STAFF REPORT
COMMUNITY DEVELOPMENT DEPARTMENT

HEARING DATE: November 9, 2021
 TO: Mayor & City Council
 FROM: Alan Tiefenbach, Associate Planner
 208-884-5533
 Bruce Freckleton, Development Services Manager
 208-887-2211
 SUBJECT: H-2021-0042
 Intermountain Wood Products Expansion
 LOCATION: The properties are located at 255, 335, 381, and 385 S. Locust Grove Rd, and 220, 300 and 330 S. Adkins Way, in the NE ¼ of the NE ¼ of Section 18, Township 3N, Range 1E.

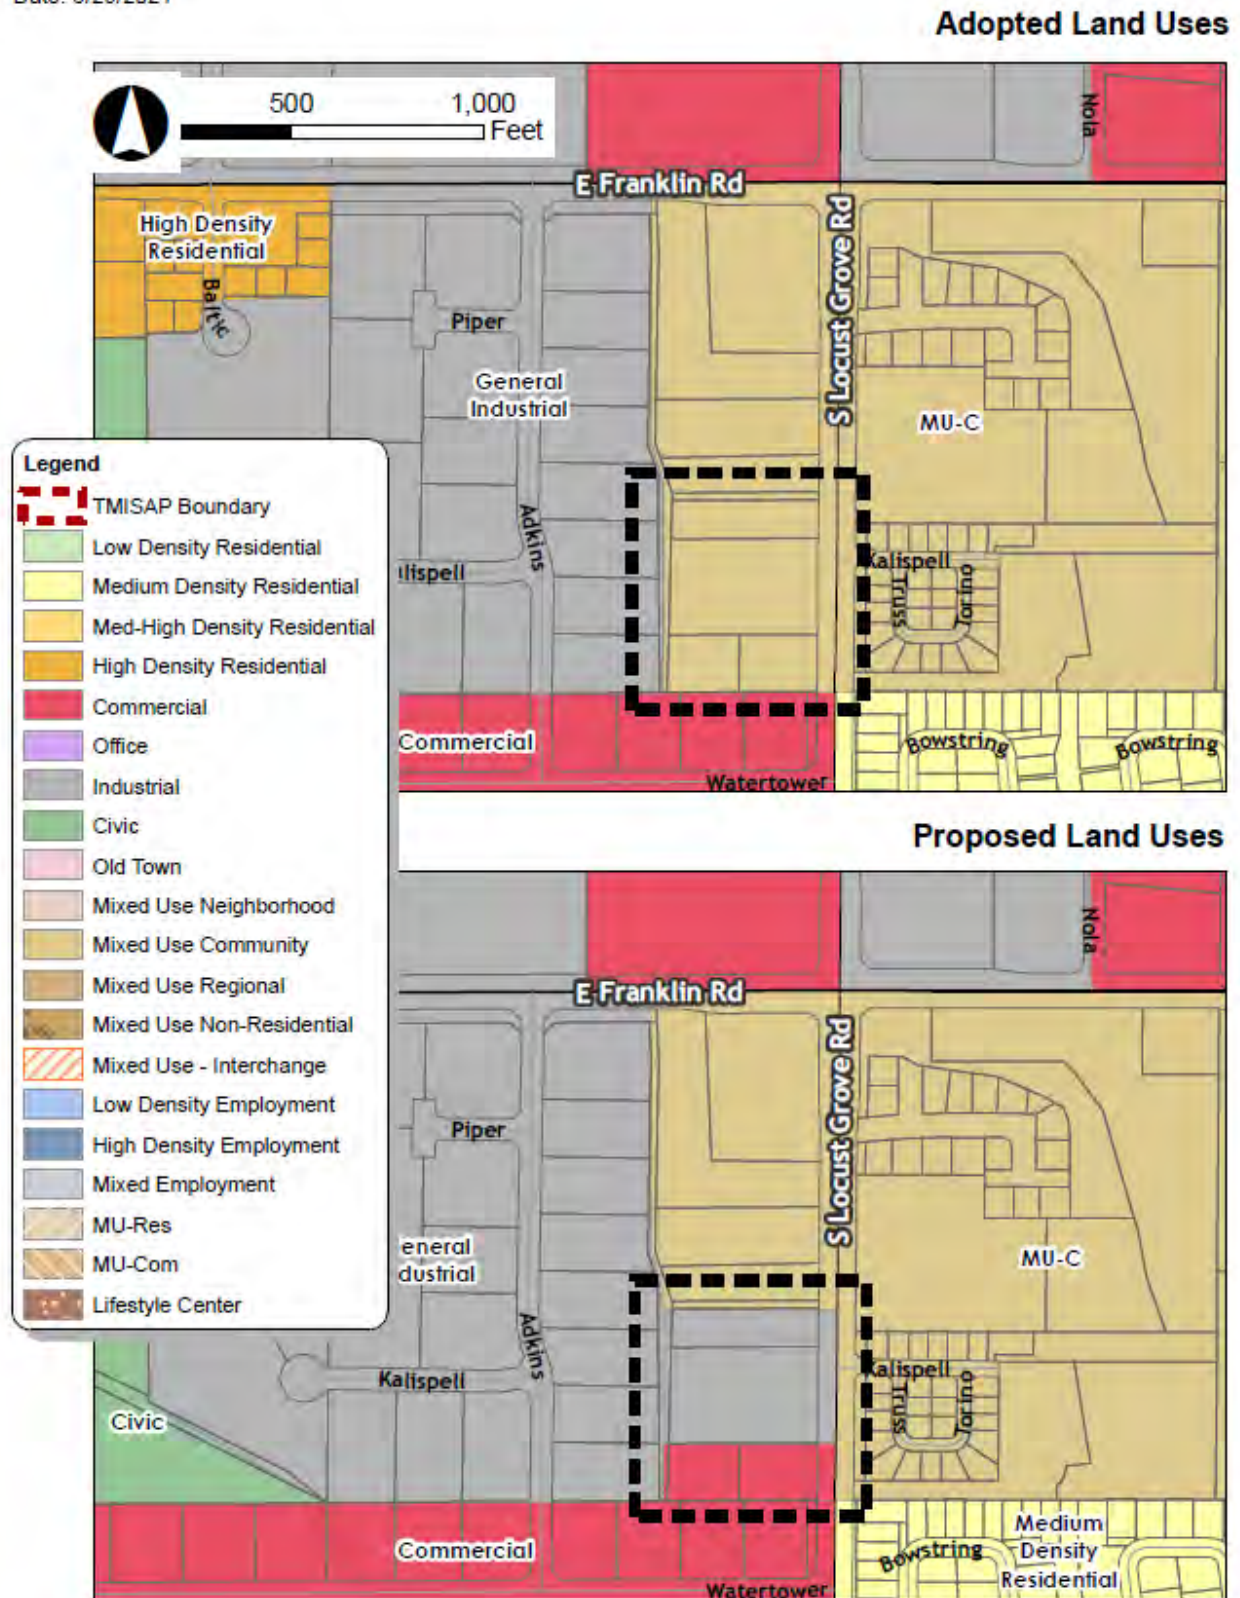
- a. Commission discussed traffic, particularly the proposed access from S. Locust Grove Rd.

- a. Commission noted the updated site plan that was presented at the meeting should be approved with a revision showing a northern cross access to the property at 255 S. Locust Grove Rd.
- b. Commission recommended approval with staff's recommendations and the additional recommendation that Council approve the S. Locust Grove Rd access.
